**Project Name: CR-880 and Sam Senter Road over the South Florida Water
Management District (SFWMD) Ocean Canal Intersection Improvements and
Bridge Replacement.**

Project Number: 2019803

Addendum No. 4

Date of Issuance: October 9, 2026

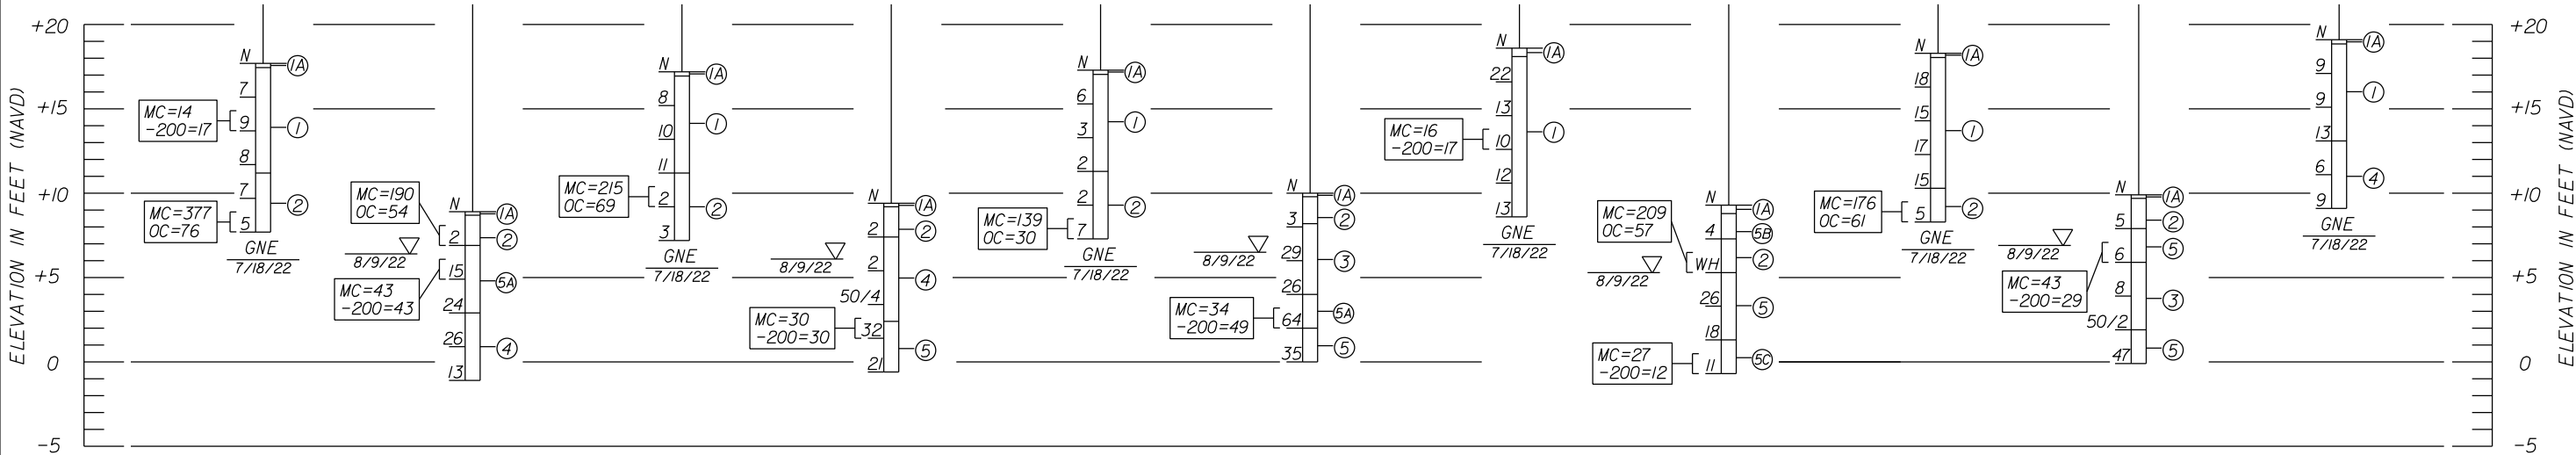
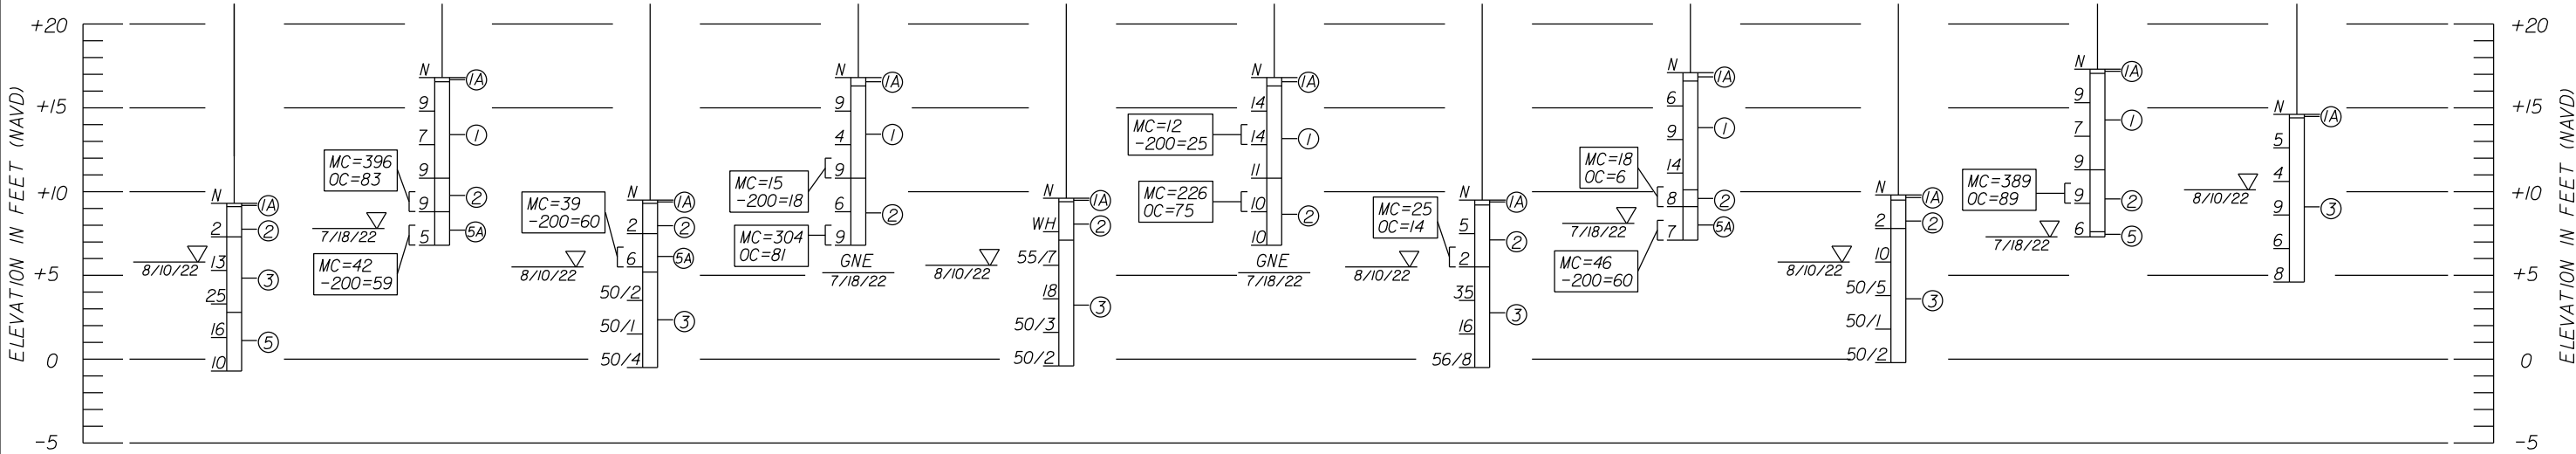
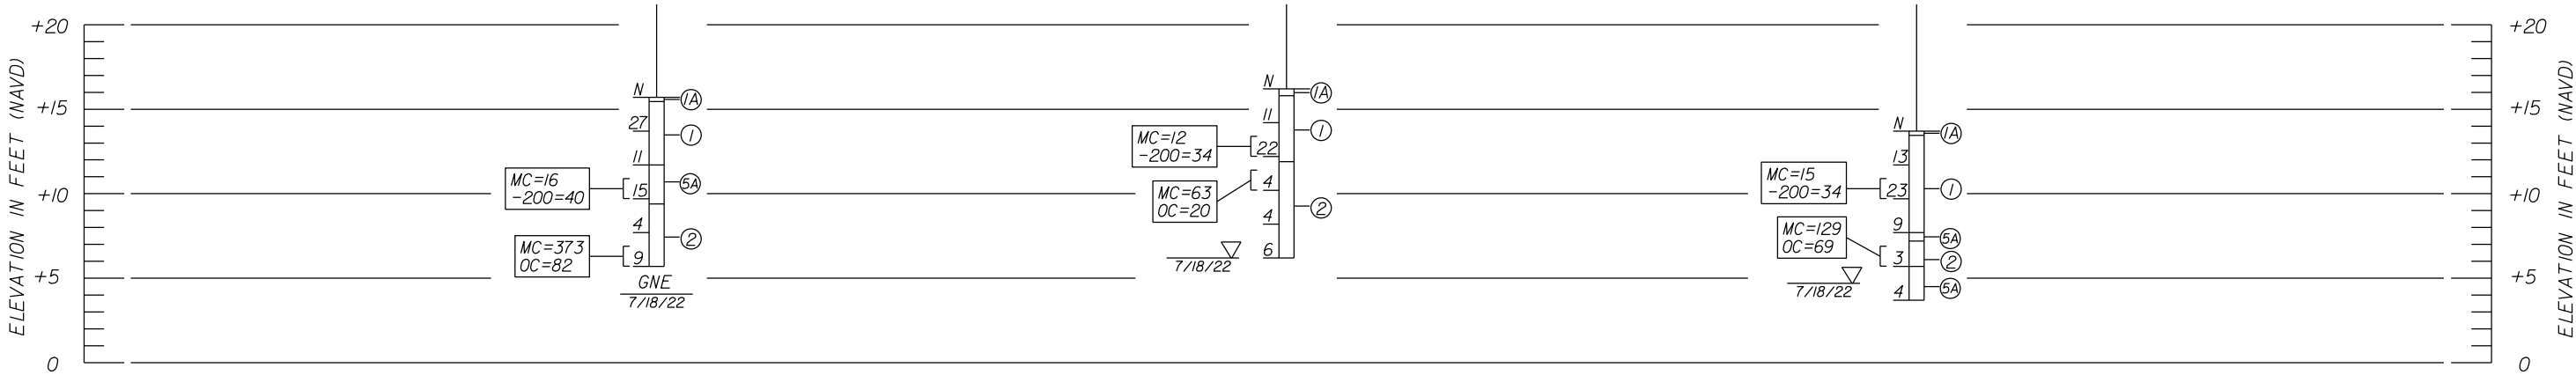
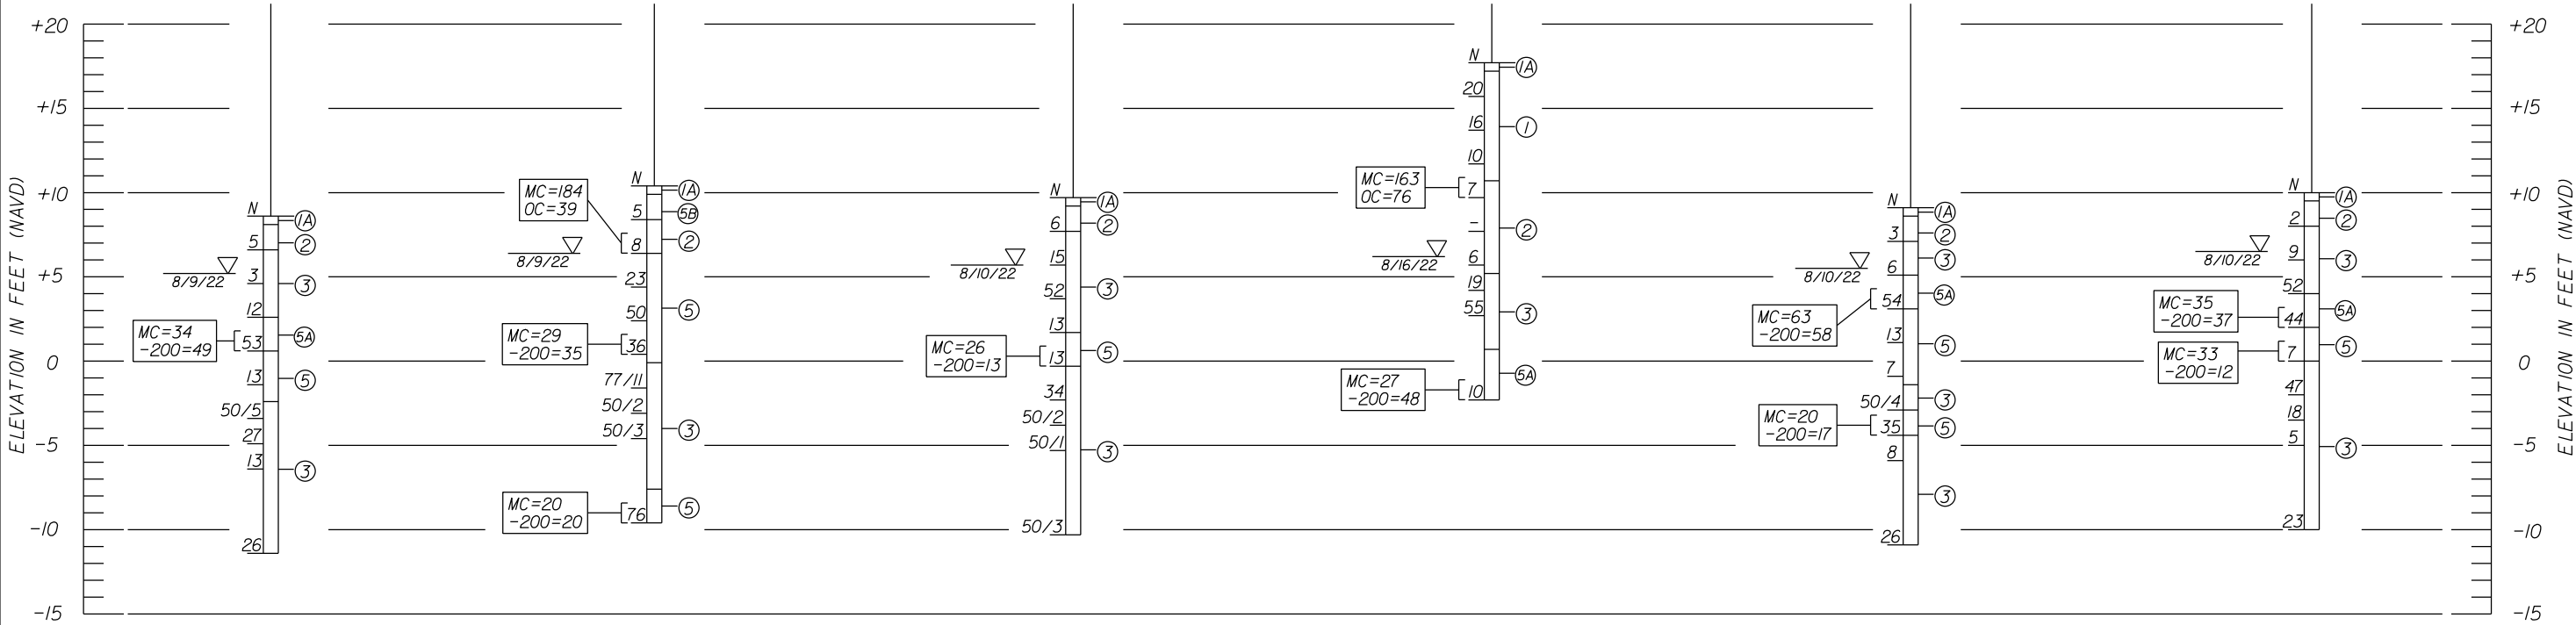
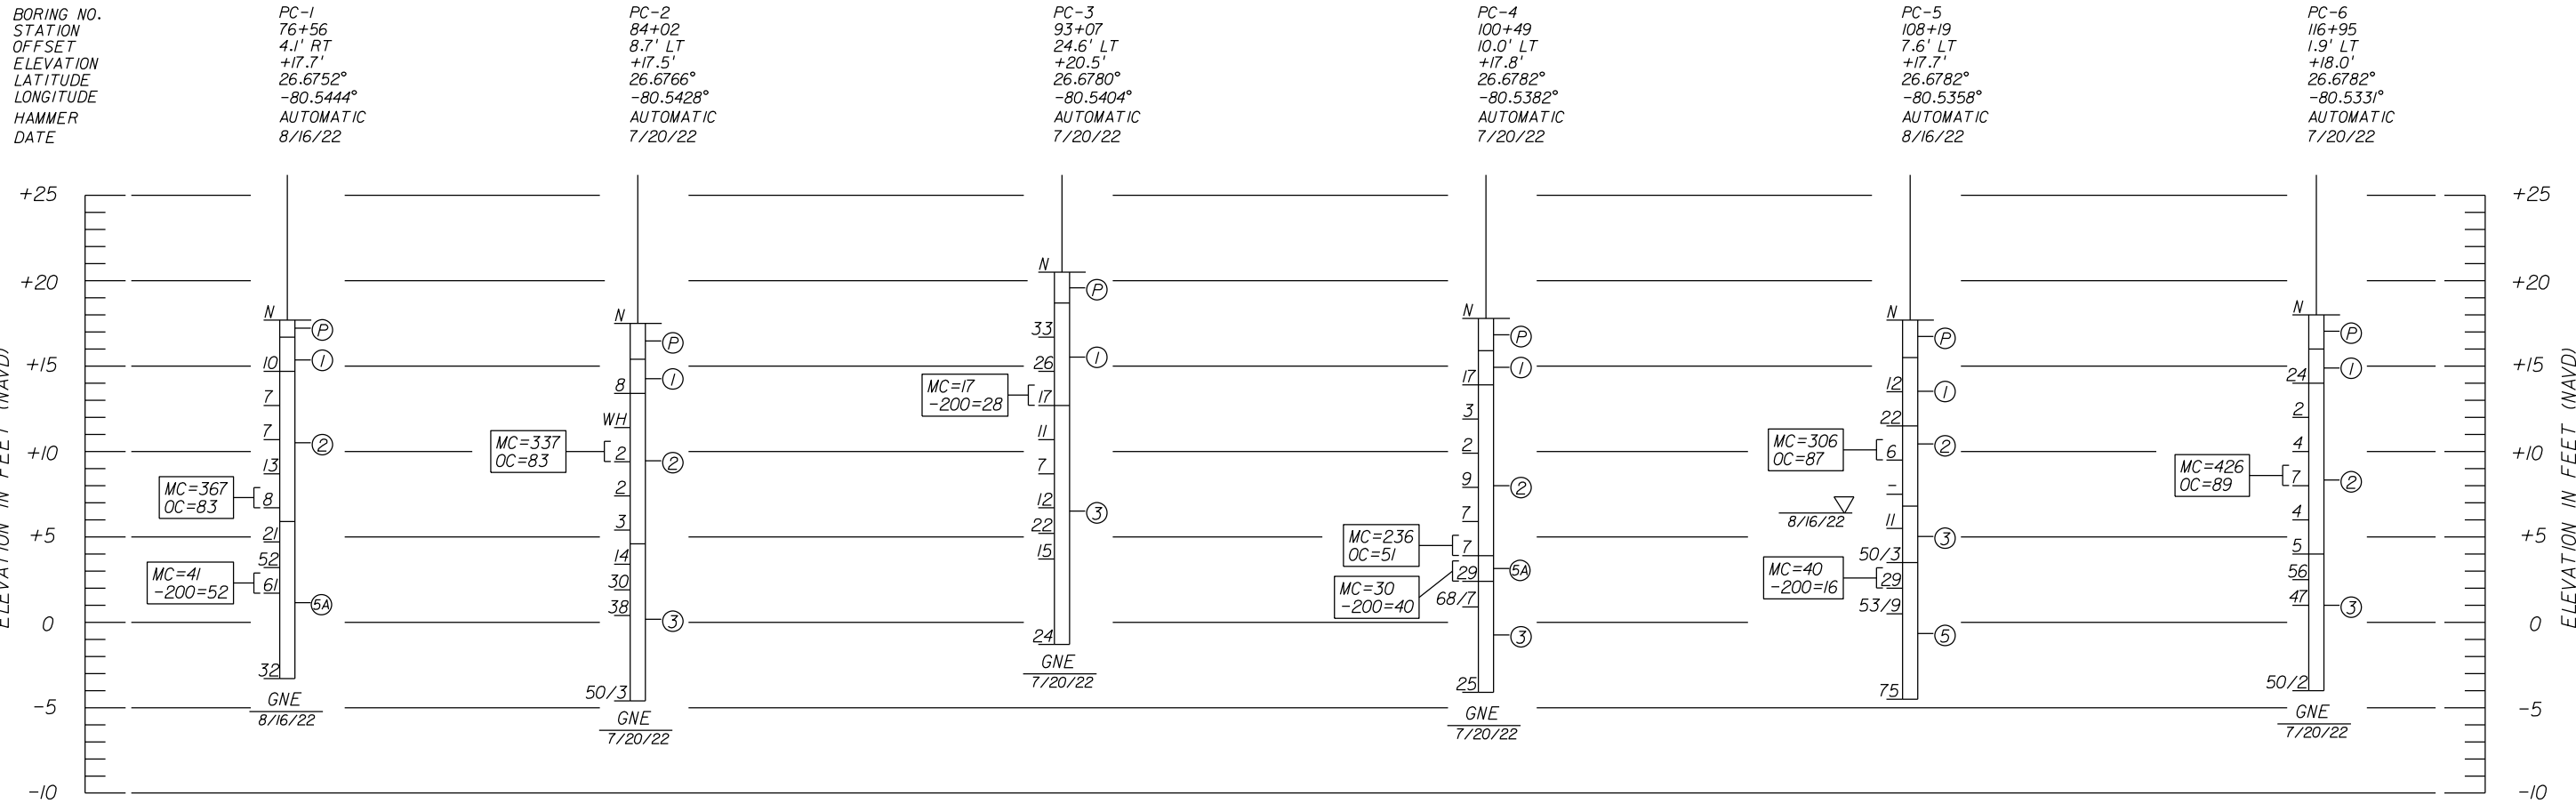
QUESTION: Could you provide the Soil Survey sheets in the roadway plans? They are mentioned in the table of contents, but the sheets are missing in the plans.

QUESTION: It appears plan sheets C2 1 of 3, C2 3 of 3, and GR-1 thru GR-6 are missing from the bid documents. They are listed on the cover sheet. Can they please be provided?

QUESTION: Please provide the Roadway Soil Survey sheets GR-1 thru GR-6.

RESPONSE: Sheets GR1 – GR6 have been provided in this addendum.

RESPONSE: Sheets C2 1 of 3, C2 3 of 3 and GR1 – GR6 have been provided in the addendum.

RESPONSE: Provided in this Addendum
